SPECIAL
CALL
COUNCIL
MEETING
PACKET

DR-2-12
201 N. 1ST STREET

Design Review

**DESIGN REVIEW COMMISSION
MINUTES
Thursday, August 16th 2012**

GENERALIZED MASSING:

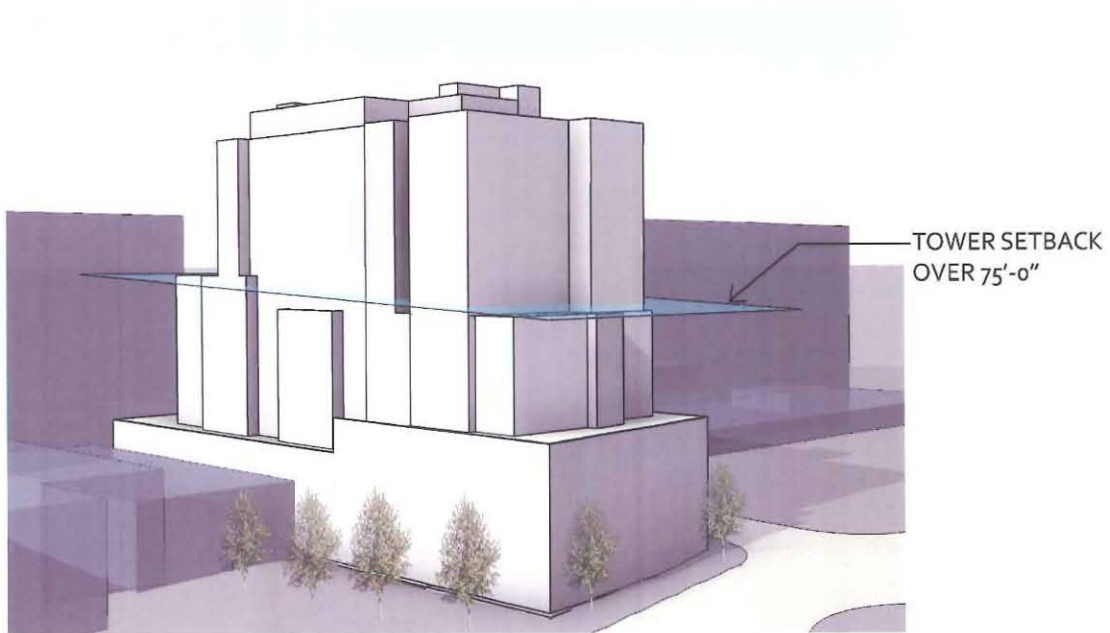
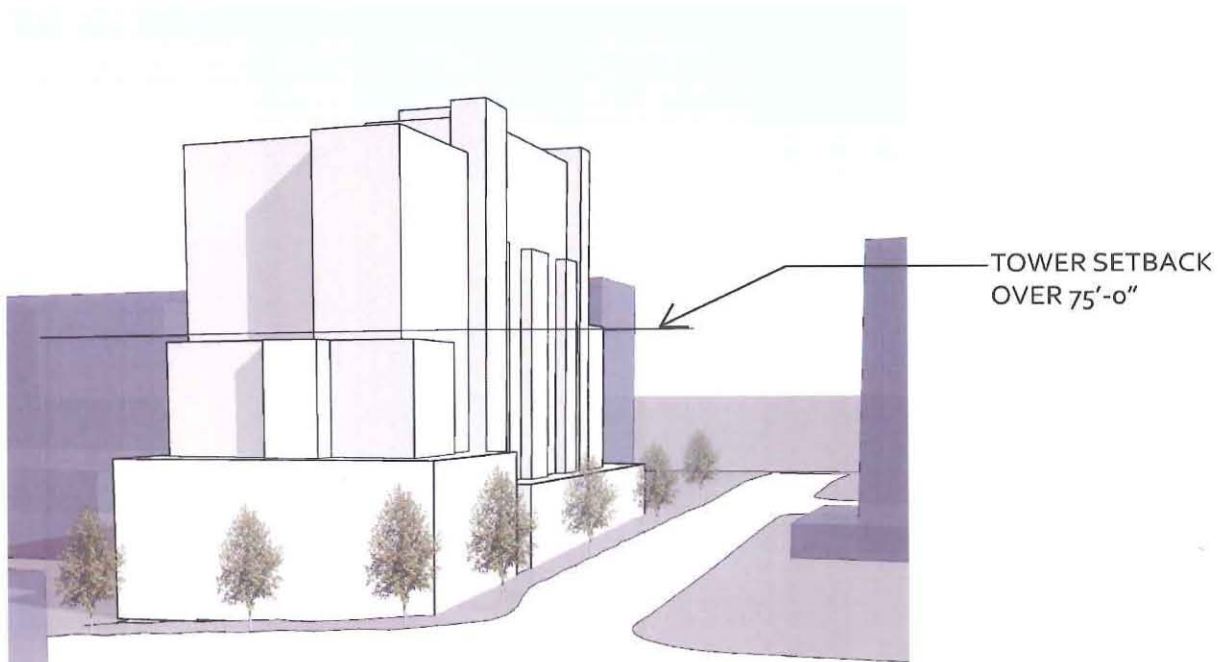
The applicant addressed the rest of the commission and asked if they agreed with Commissioner Mueller that a taller building with less mass would be a better design for them to bring back and present at the second meeting. Commissioner Bowlby stated that she believed the CDA North building was an abomination to the views in that area. Applicant, Greg Hills asked if she had any suggestions. She added she likes the idea of creating as many open views and vistas as possible for the buildings behind the property.

Planning Director Yadon addressed the commission to ask what they would like the applicant to bring back for the second meeting. Mueller referenced the power point and stated that it would be best to have less massing and a taller building design to create less impact on the view.

- Provide a conceptual plan with less massing and a taller structure to create less impact on the view.

PERSPECTIVE VIEW FROM LAKE LOOKING NORTH:

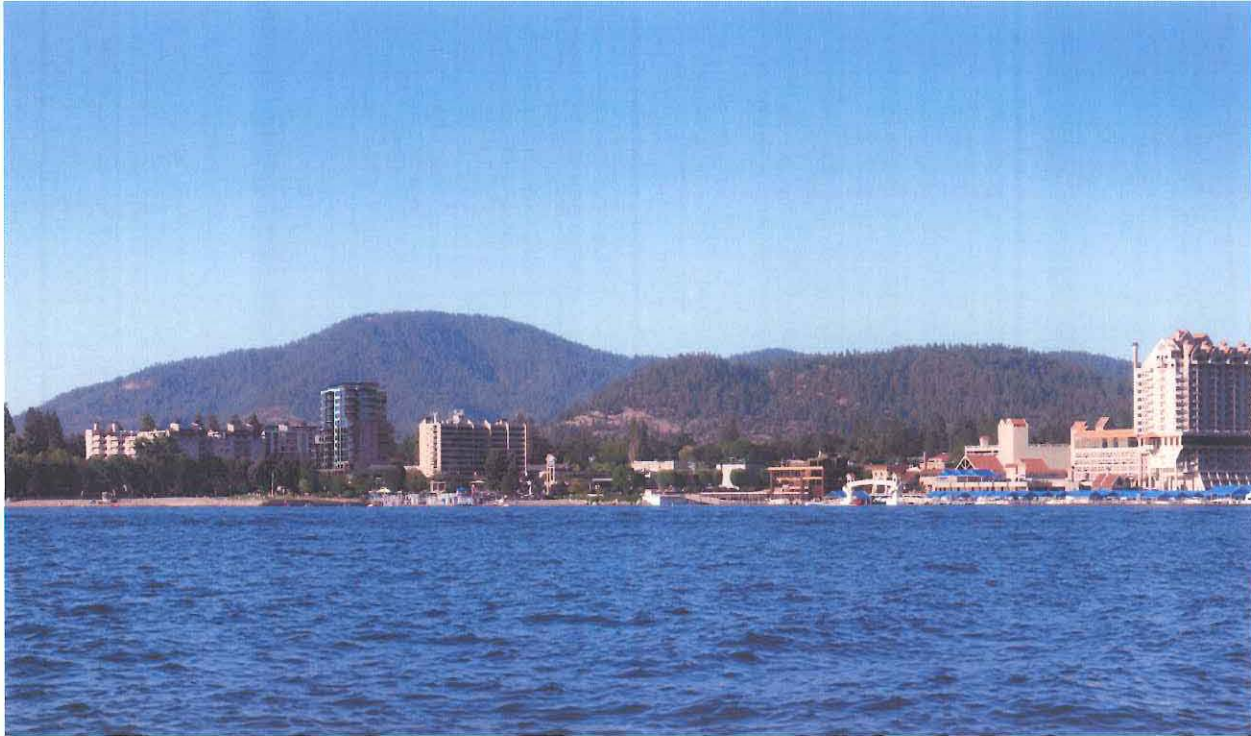
Commissioner Mueller made a comment regarding the top part of the building, that he preferred the red color in from the first meeting rendering over the white color in their final presentation. Patano agreed that the red would be preferable. Michael Noda stated they would go back to more red tones.
